FNF Trend Fashion Ltd.

H -2282/1 NOBI ULLAH MIR MANSION, HAZI LIAKAT ALI MIR ROAD, JAMGORA, ASULIA, DHAKA.
(23.934778N, 90.289052E)
27th December 2017

**Columns appeared to be stressed in excess
of normal design limits**

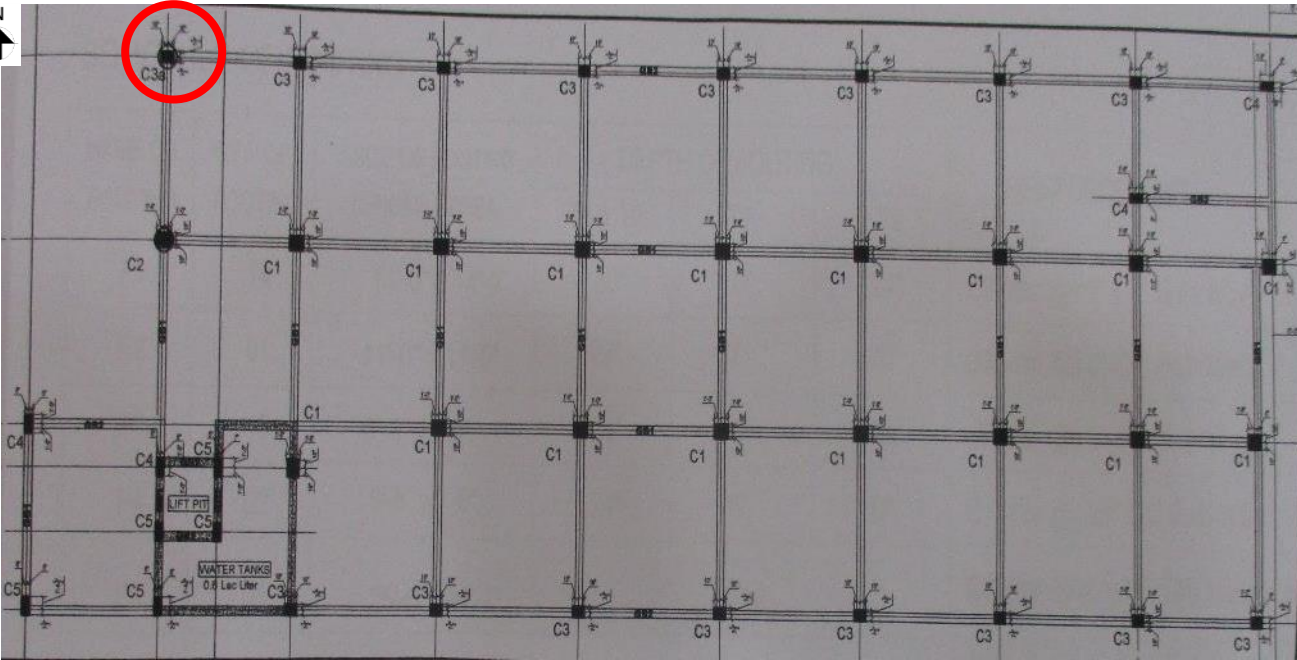
Cursory calculation indicates that highlighted columns appear to be stressed above normal design limits. Factory engineer need to check column stress and an Engineering Assessment(EA) must be carried out and factory should take necessary action according to report.

Provided Column Layout

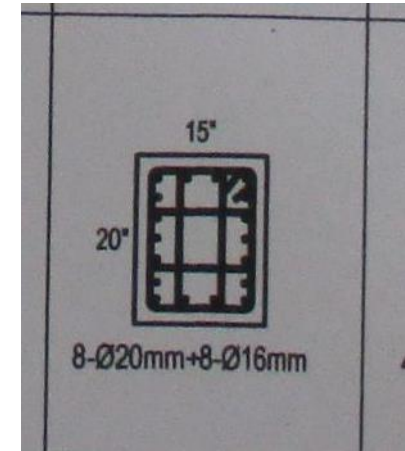
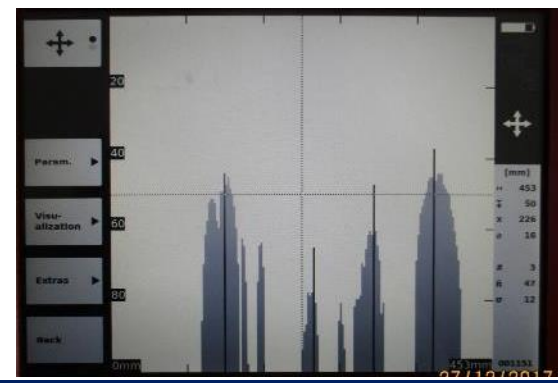
16 nos. rebar were shown in column schedule for C-3a type column in 1st floor

Ferro Scanning Image of marked column

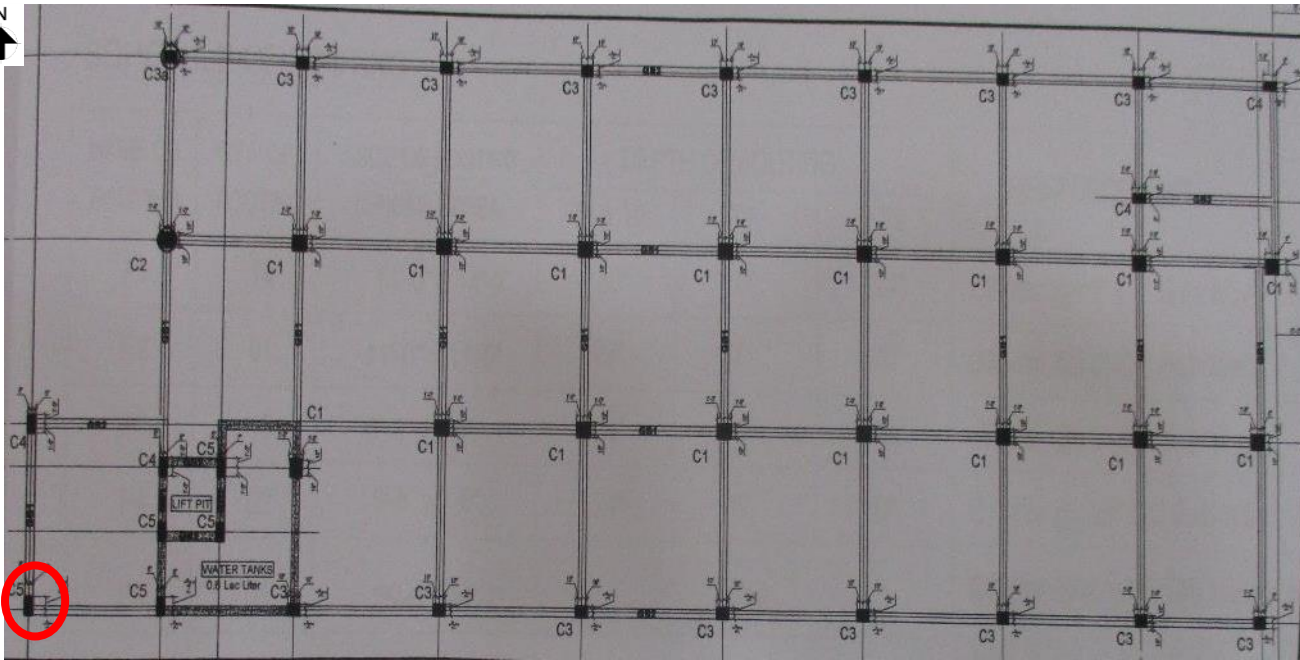
14nos. (5x4) rebar was observed by ferro scanning of C-3a type column on 1st floor. But as per column schedule of the provided drawing, there are 16 nos. rebar

Provided Column Layout

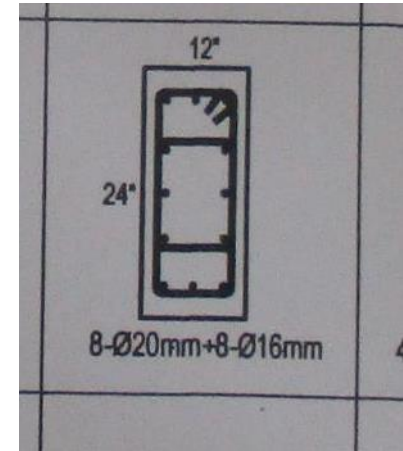
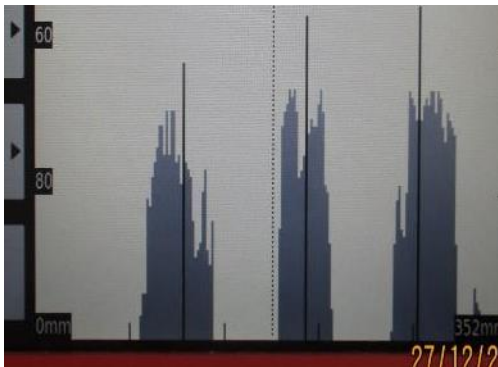
16 nos. rebar were shown in column schedule for C-5 type column in 1st floor

Ferro Scanning Image of marked column

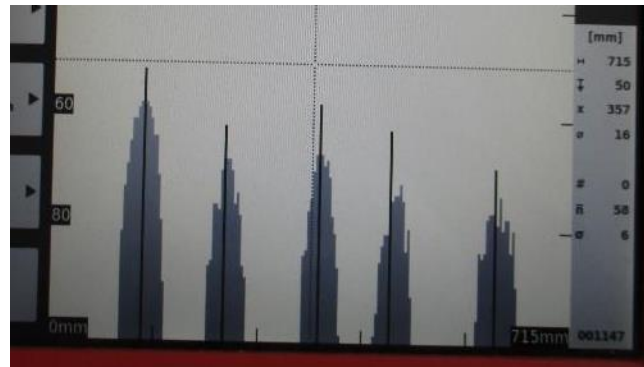
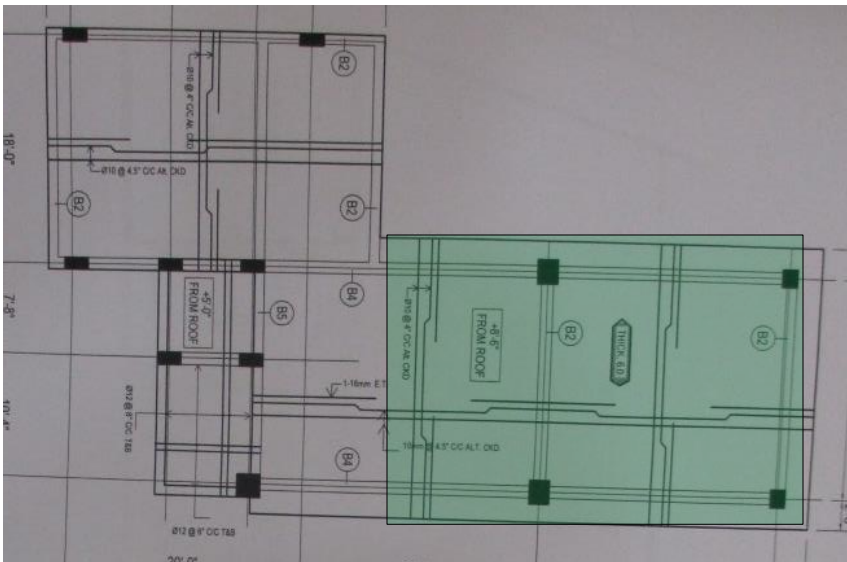
12nos. (5x3) rebar was found by ferro scanning in C-5 type column in 1st floor. But in column schedule, 16 nos. rebar was mention in column schedule in provided drawing.

Stair roof detail in provided drawing

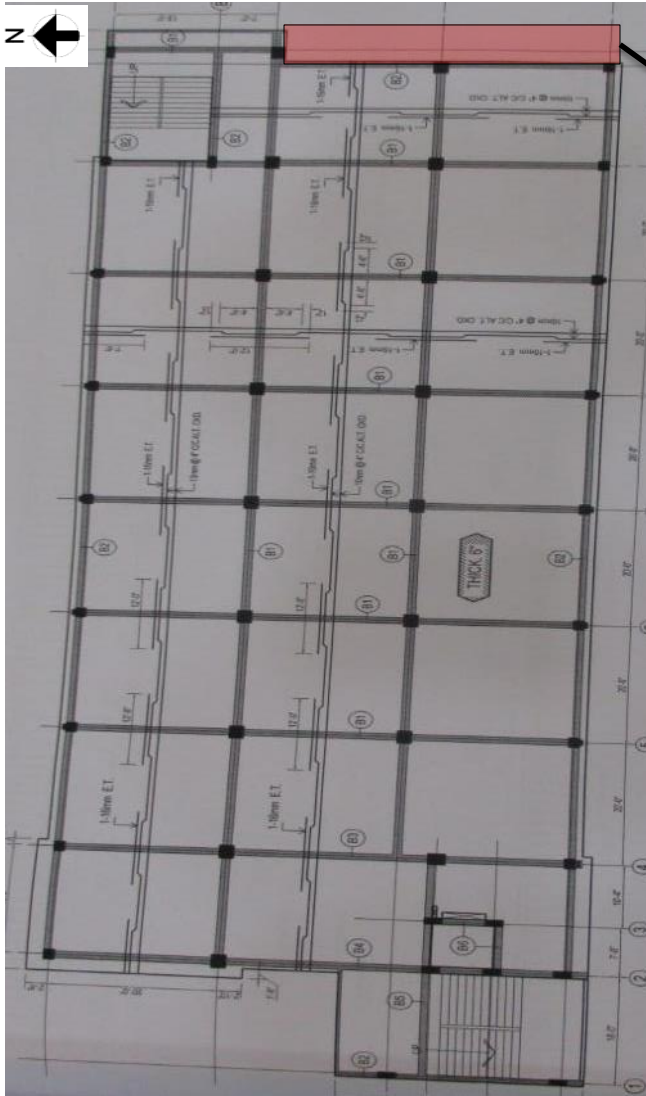
The beam- column layout was different than the provided drawing. The highlighted portion of the stair roof slab was not constructed. Also, the red marked column is not shown in the drawing. The column was constructed from the slab.

The marked brick column was not shown in the drawing. The brick column carry the load from the roof slab. Factory engineer is required to assess the capacity of the brick column.

Corrosion of roof top exposed reinforcement

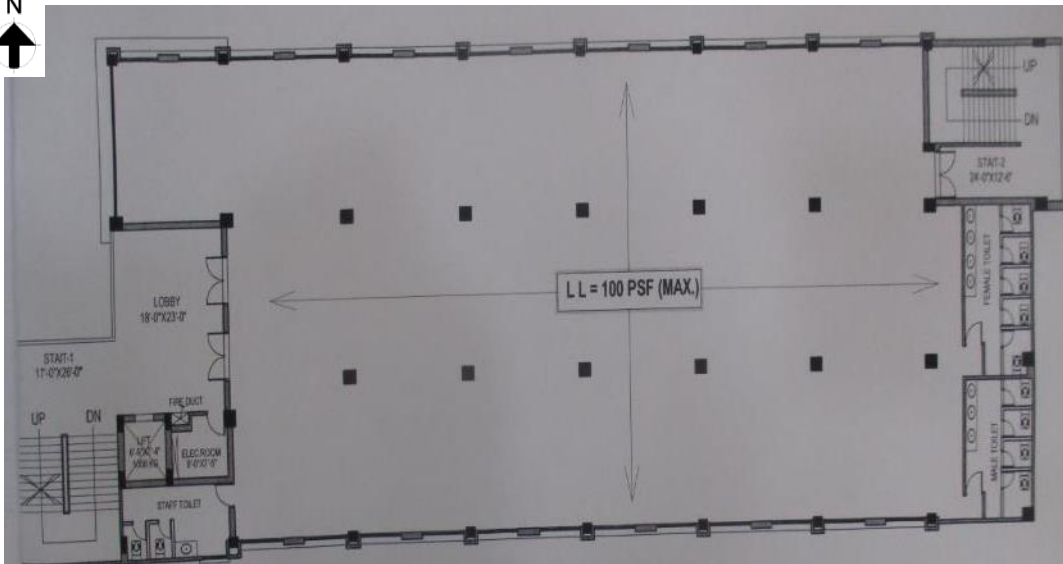
Corrosion was observed on almost all exposed reinforcement of column on roof top. Factory is required to take proper measures to protect rebars from corrosion.
